Class II change apply for WRT54G V.2
(From WRT54GV.2 **FCC ID: Q87-WRT54GV2**)

The Add Power Delay Function

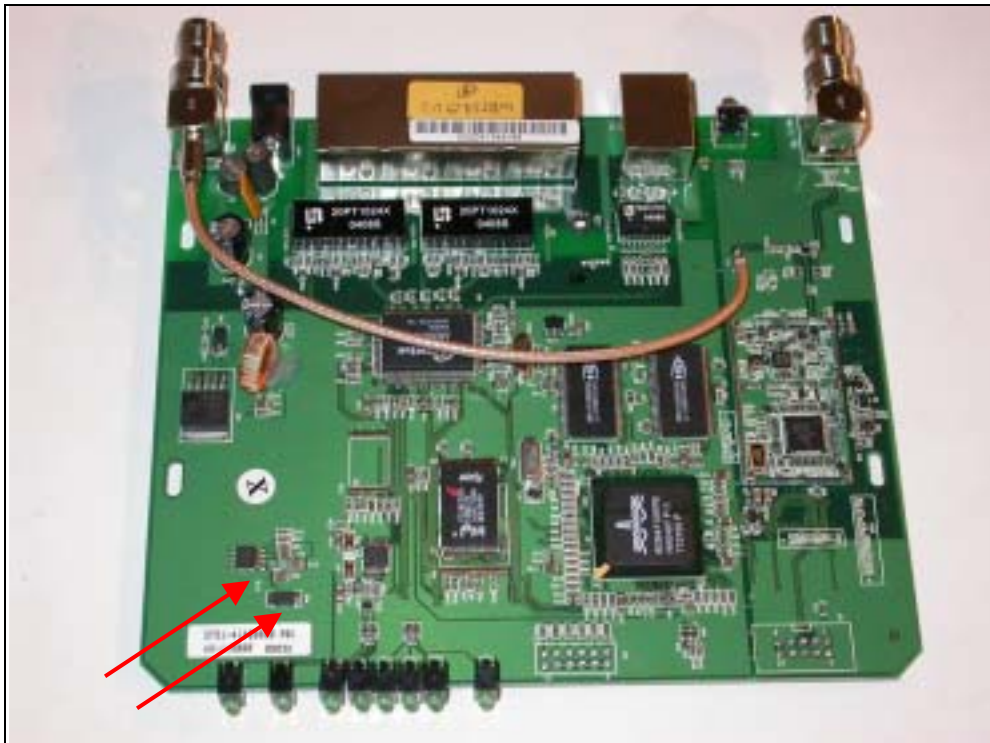
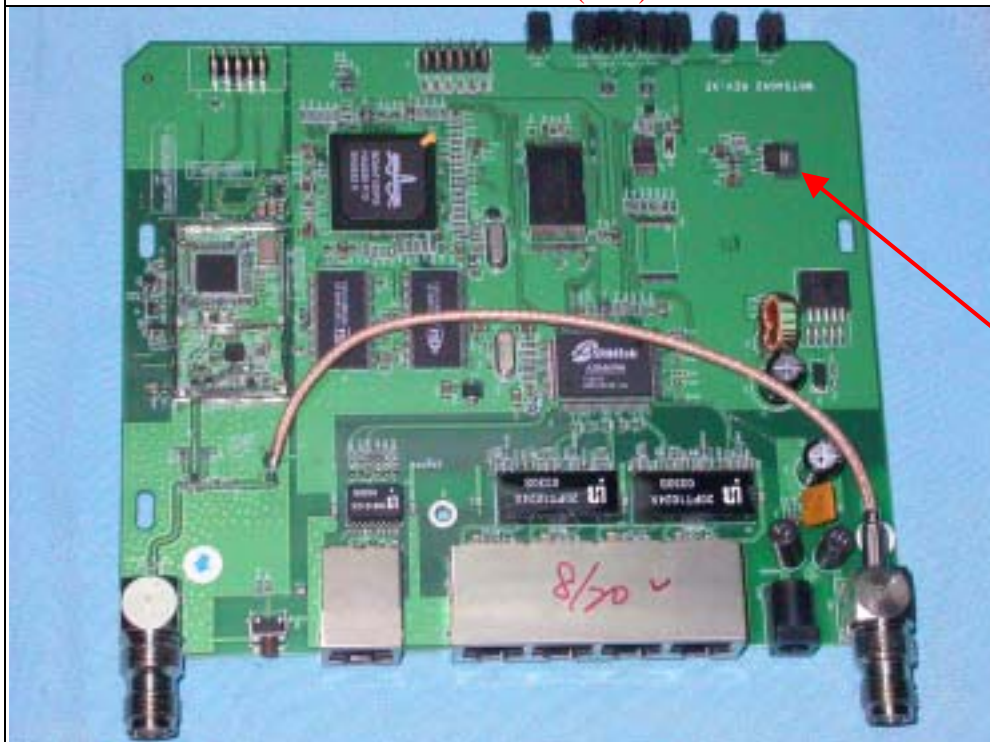
AFTER (new)

BEFORE(old)
